Dundrum Village
Strategic Housing
Development, Main Street,
Dundrum, Dublin 14

**PLANNING STATEMENT /
RESPONSE TO ABP
OPINION**

March 2022

The Report also responds to the An Bord Pleanála Stage 2 Opinion (ABP-311553-21) which is attached as **Appendix A**.

Figure 4.3 Public Open Space

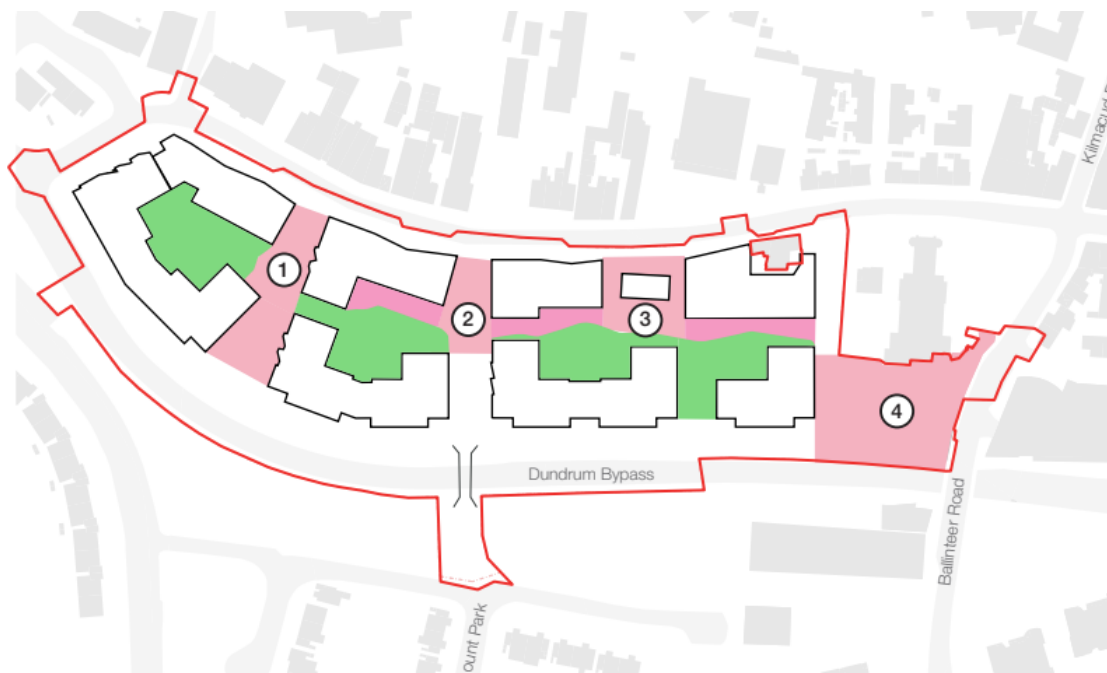
The ABP Opinion seeks confirmation on compliance with Development Plan standards for public open space (Ref. Specific Information Item 14).

The *Dun Laoghaire Rathdown County Development Plan 2016-2022* (Ref. Section 8.2.8.2) requires that a minimum of 10% of the site area is dedicated to public open space with flexibility provided for lower levels of provision in certain circumstances. The proposals above exceed this quantitative measure and, as detailed in this report, are of a very high quality and designed to respond to their Town Centre location.

The *Dun Laoghaire Rathdown Draft County Development Plan 2022 -2028* (Ref. Section 12.8.3.1/ Table 12.8) includes a figure of 15% of site area with allowances for lower level of provision in high density urban schemes and / or smaller infill sites. In any event, the proposed development is deemed to meet the Draft Development Plan requirements in relation to public open space. Refer to table below.

<small>PLANNING AND DEVELOPMENT CONSULTANTS</small>	 <small>Not to scale</small>	Project: Dundrum Village SHD
		Title: Figure 5.1 : Residential Use in MTC Zone

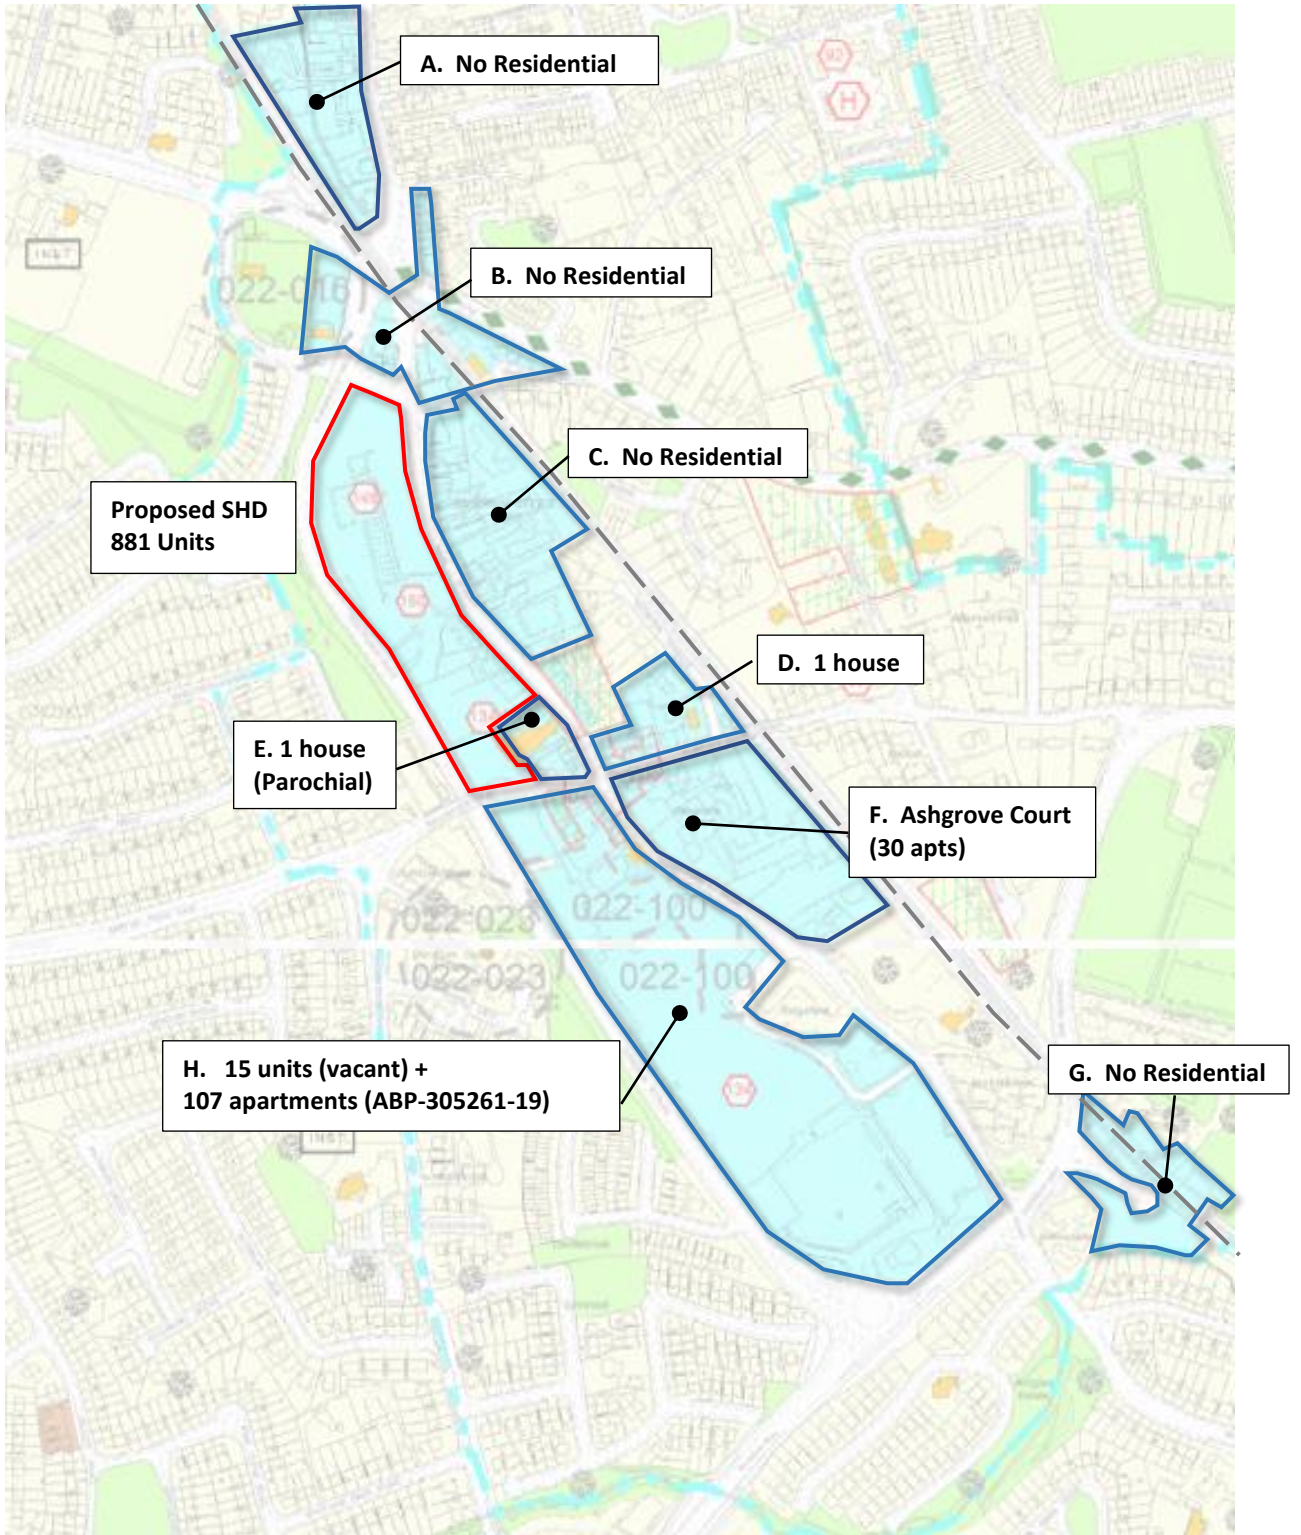
1. Development Strategy: *Further justification for the proposal in light of the 'MTC' zoning objective, 'to protect, provide for and or improve major town centre facilities', and non-residential uses proposed. The predominant use proposed in the scheme is residential, a town centre zoning would envisage a greater degree of mixed use and the site is located within the major town centre area for Dundrum.*

The entire Dundrum MTC area as illustrated on **Figure 5.1** below has extremely limited number of residential units with only 47 residential units in total, as follows:

The SHD permission for 107 units (ABP-305261-19) will provide a residential activity to the southern end of the Phase 1 development and this is supplemented by apartments opposite at Herbert Hill and Rockfield (both Residential zoned)

On the basis of the above, it is considered that the proposed development will help to redress a significant deficit in residential use within the MTC lands which will advance the MTC objectives and produce a more vibrant living town centre.
